Introduction

The purpose of this report is to provide an accessibility review of the proposed alterations and additions to the existing Merchantile Hotel building at 25-27 George Street, Sydney for the purpose of a hotel, bistro dining areas, lounge bars and eleven (11) accommodation rooms including two (2) accessible rooms with ensuites.

Accessibility Assessment

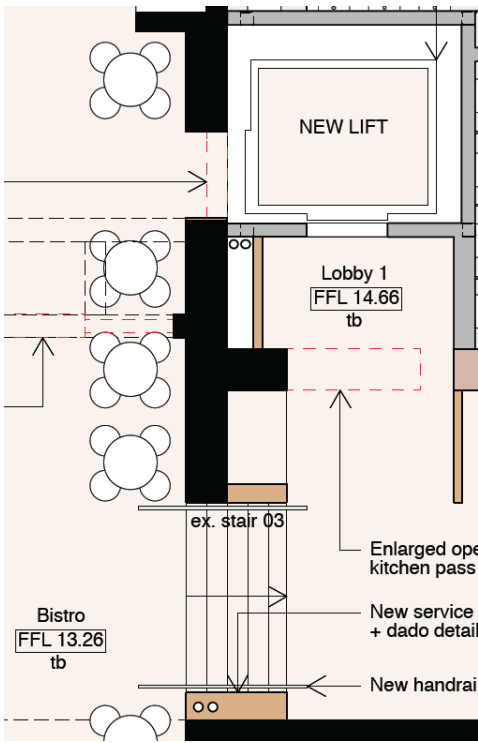
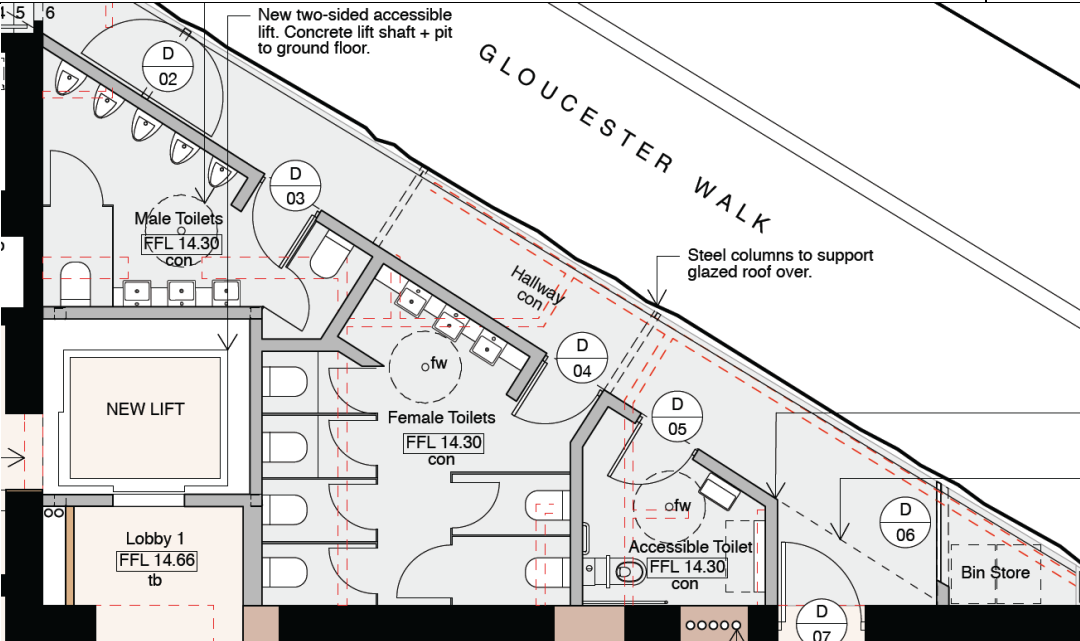
BCA / DDA Compliance	Complies
<p>1. To ensure appropriate pedestrian access from George Street that is wheelchair accessible the northern doors shall incorporate lever door handles and upgrade the external pavement at the northern doorway to provide an accessible entrance into the premises in accordance with AS1428.1 to satisfy Part D3.2 of the BCA 2016 and DDA Premises Standards.</p> <p>2. The new works will also install at least two signs at the inaccessible stairway entrances and a third sign at the northern doorway advising of the accessible northern doorway consistent with D3.6 of the BCA and DDA Premises Standards.</p>	<p>YES</p> <p>YES</p>

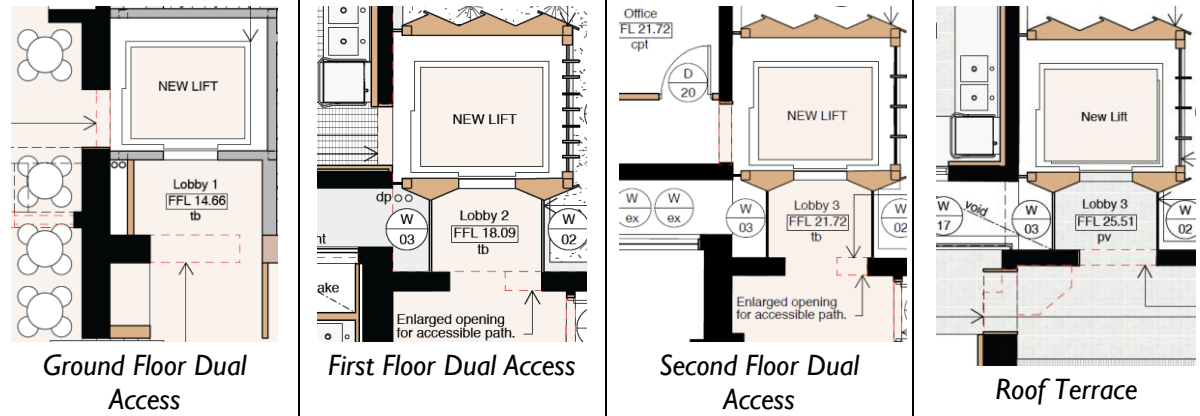
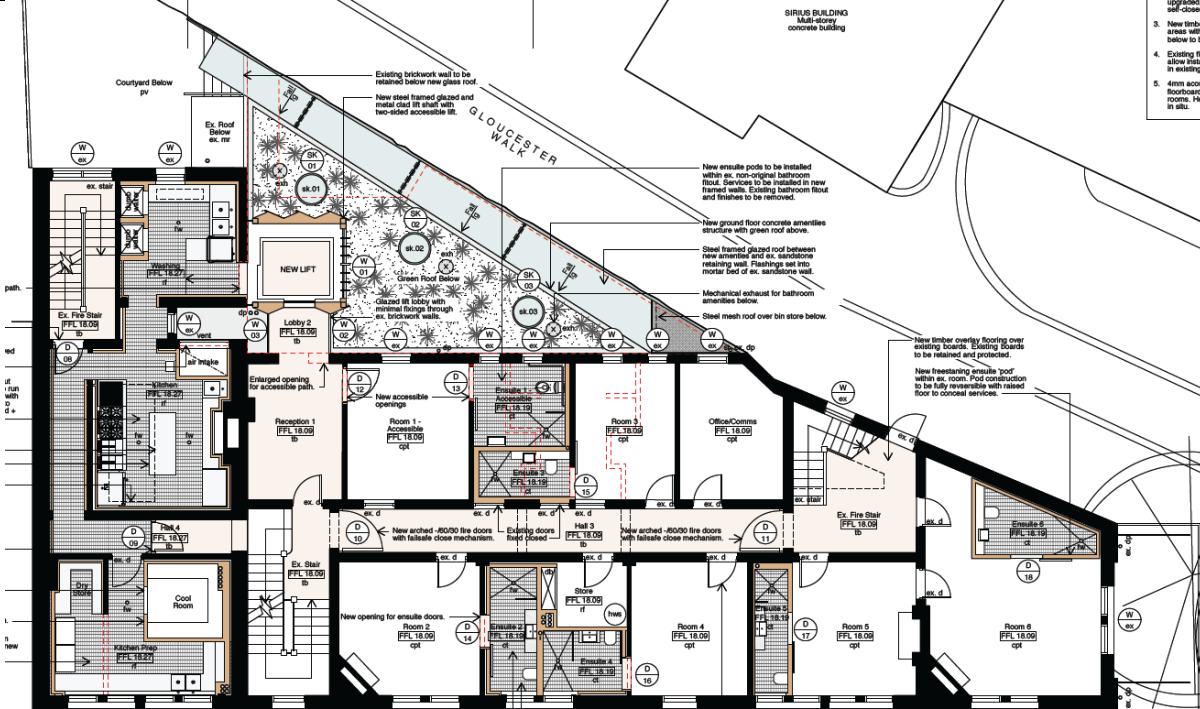
3. **Entrance Stairways** – The existing stairways are generally not subject of any new works.

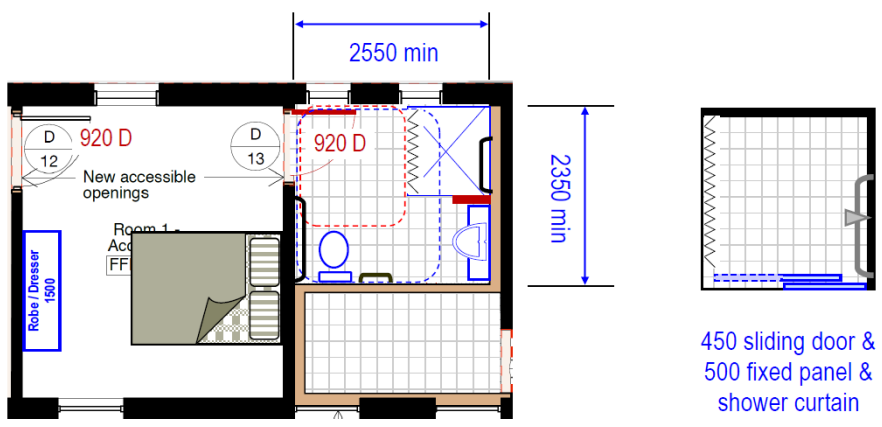
8. Bistro & Courtyard - The circulation spaces within the ground floor bistro provide appropriate access for Turning, Passing and to the courtyard doorways which include a 920mm door and level thresholds to ensure equitable access to satisfy Part D3.3 of the BCA and DDA Premises Standards.		YES

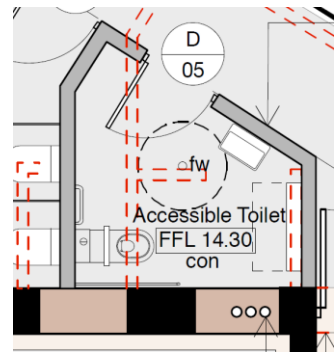
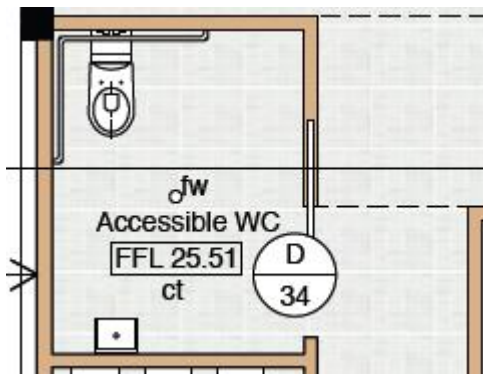
<p>18. Notwithstanding the minimal intervention on the first floor, retention of the central corridor and limited access for people who use a wheelchair beyond the</p>	<p>YES</p>
